**SHEARON HARRIS NUCLEAR POWER PLANT, UNITS 2 AND 3
DOCKET NOS. 52-022 AND 52-023
SUPPLEMENT 2 TO RESPONSE TO REQUEST FOR ADDITIONAL INFORMATION
REGARDING THE ENVIRONMENTAL REVIEW**

**Shearon Harris Nuclear Power Plant Units 2 and 3
Supplement 2 to Response to NRC Request for Additional Information Regarding the
Environmental Review, dated November 13, 2008**

NRC RAI #: 4.3.1-2

NRC RAI #: 9.4-1

Attachment 9.4-1A, Figure 1

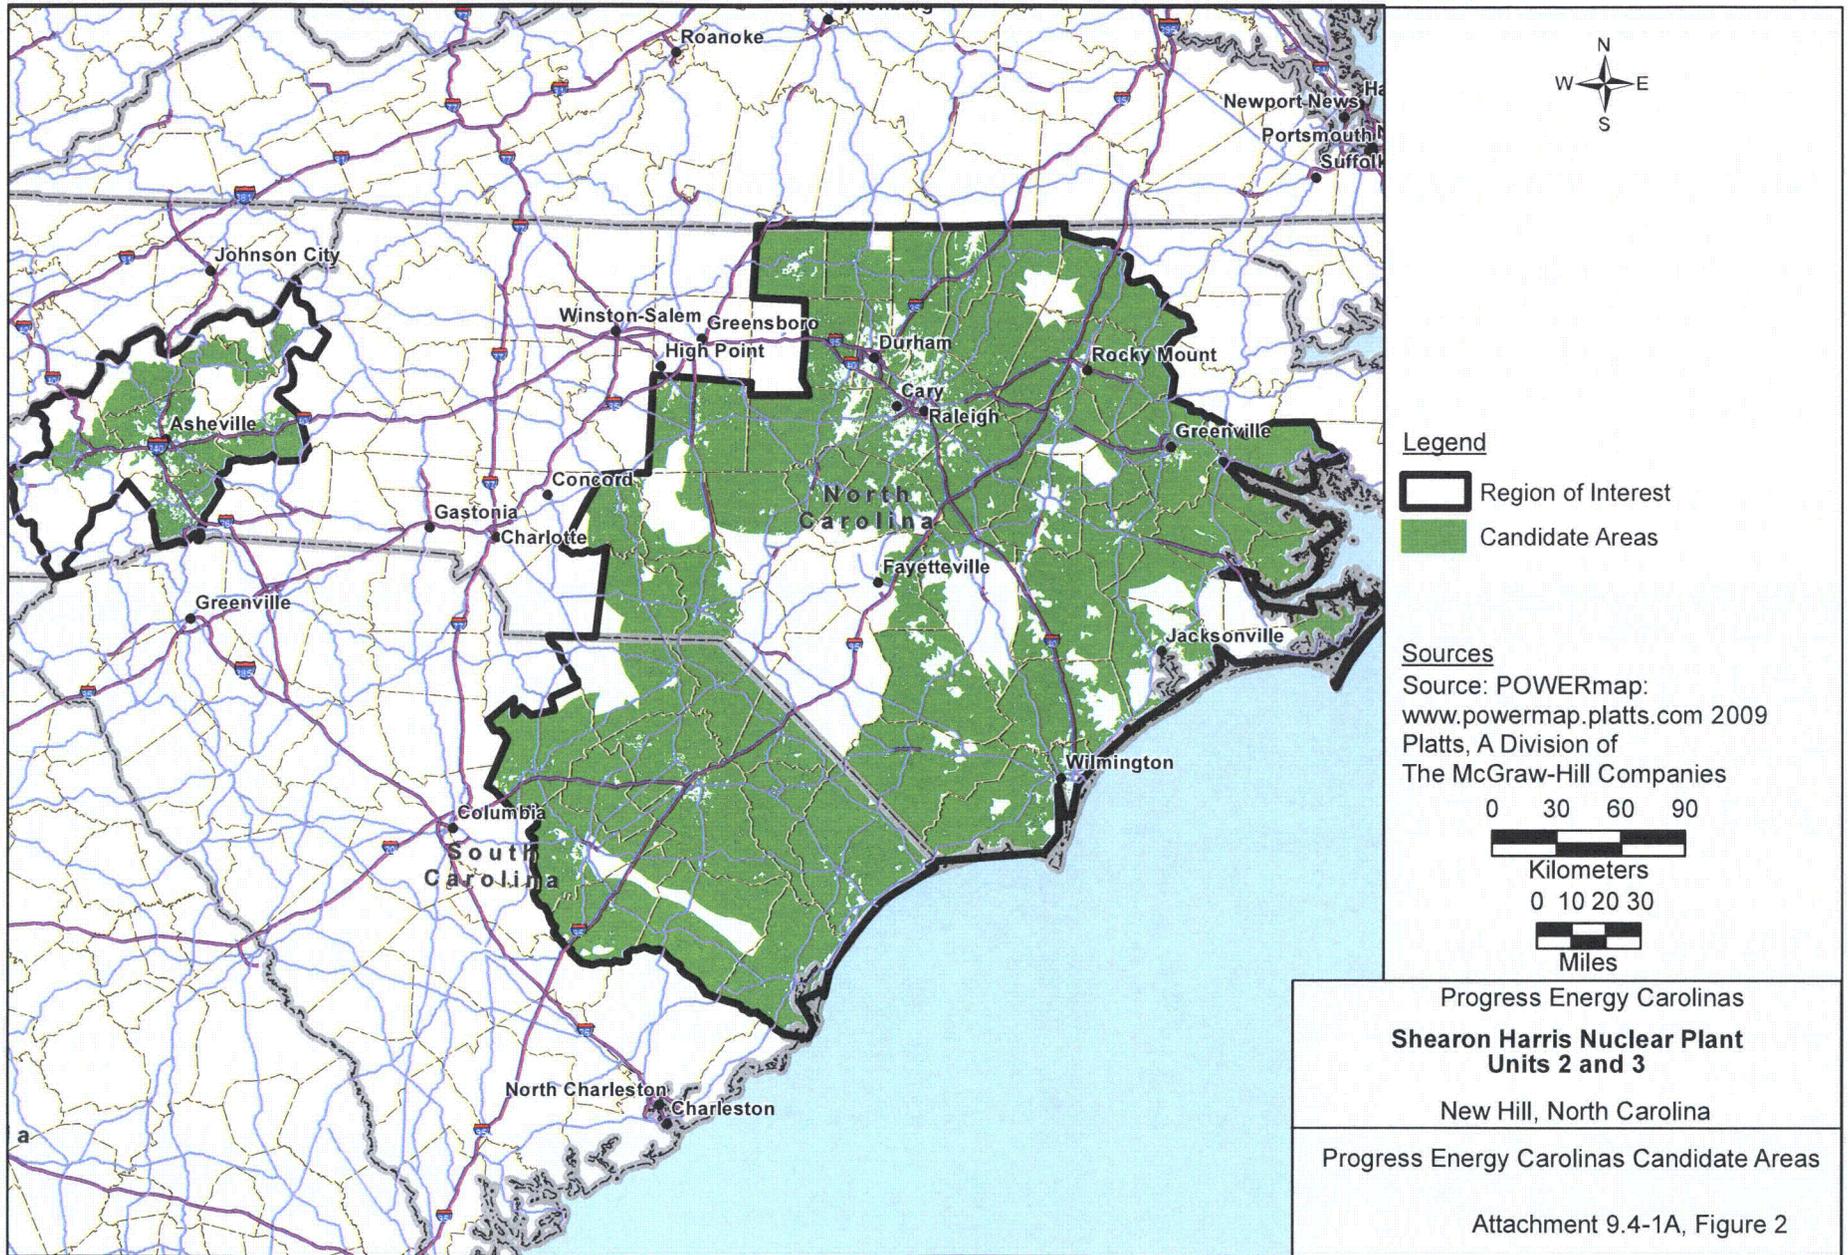
Provide supporting data and information demonstrating a quantifiable alternative site selection process in the revised ER that can be cited in the NRC EIS for the proposed construction and operation of Harris Units 2 and 3.

The alternative site selection process should follow a clear and defensible process to determine the final alternative sites, and the proposed site. Analysis performed on the four alternative sites to determine the proposed Harris site is clear and logical; however it is not clear how the region of interest was screened to provide candidate areas, potential sites, and candidate or alternative sites. Please provide a clear analysis of the site screening process from the defined region of interest to the selection of the four alternative sites.

The criteria used in the ROI screening process to identify candidate areas were consistent with those identified in ESRP Section 9.3 (Reference 9.4-1 01). The criteria included the following, as identified on Attachment 9.4-1A:

Screening information was obtained from publically accessible geographic information system (GIS) database websites. The GIS information was layered to produce a figure that represented the suitable candidate areas for the potential placement of a nuclear power facility (Attachment 9.4-1A).

Figure 1 identifies the criteria used to screen the ROI (some of the identified excluded areas overlap).
